Hill of Fare Wind Farm

Technical Appendix 4.2

EIA Scoping Opinion

**Scoping opinion on behalf of the Scottish Ministers under the Electricity Works
(Environmental Impact Assessment)(Scotland) Regulations 2017**

Figure 1: Proposed development location shown on an airways chart

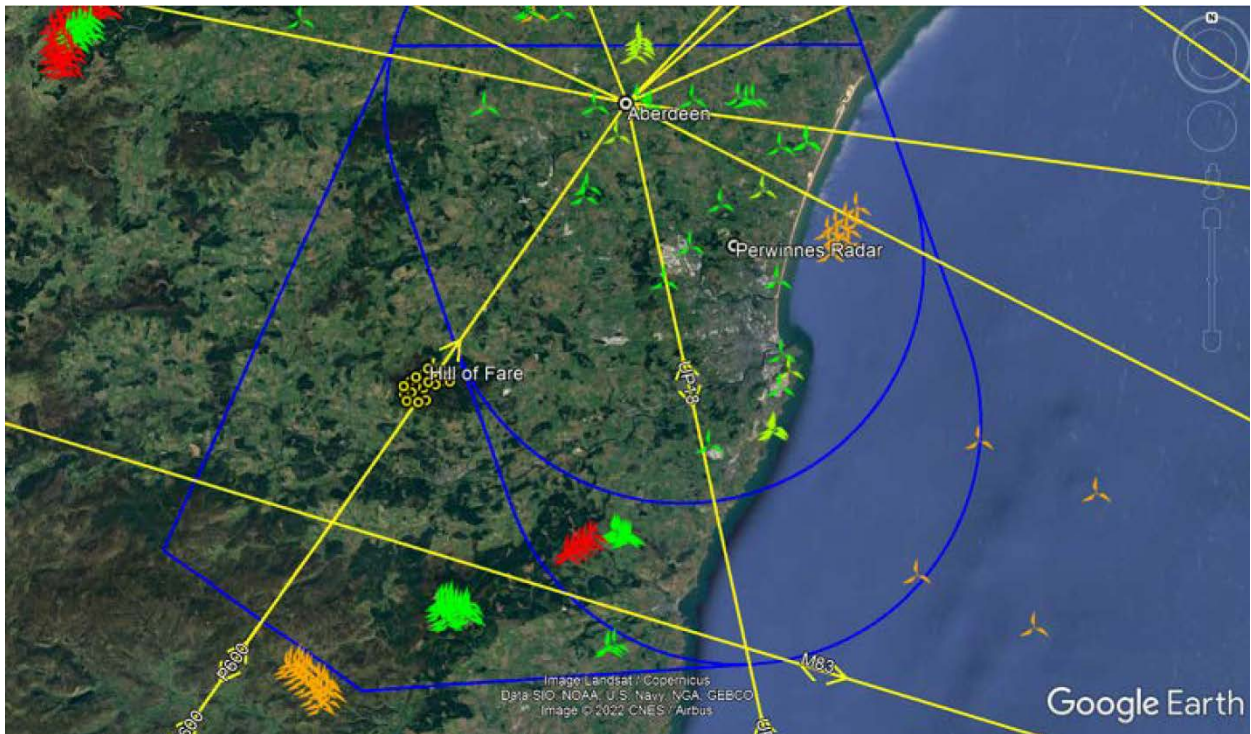
Unit or role	Comment
Prestwick Centre ATC	Unacceptable
Aberdeen ATC	Unacceptable
Military ATC	Acceptable
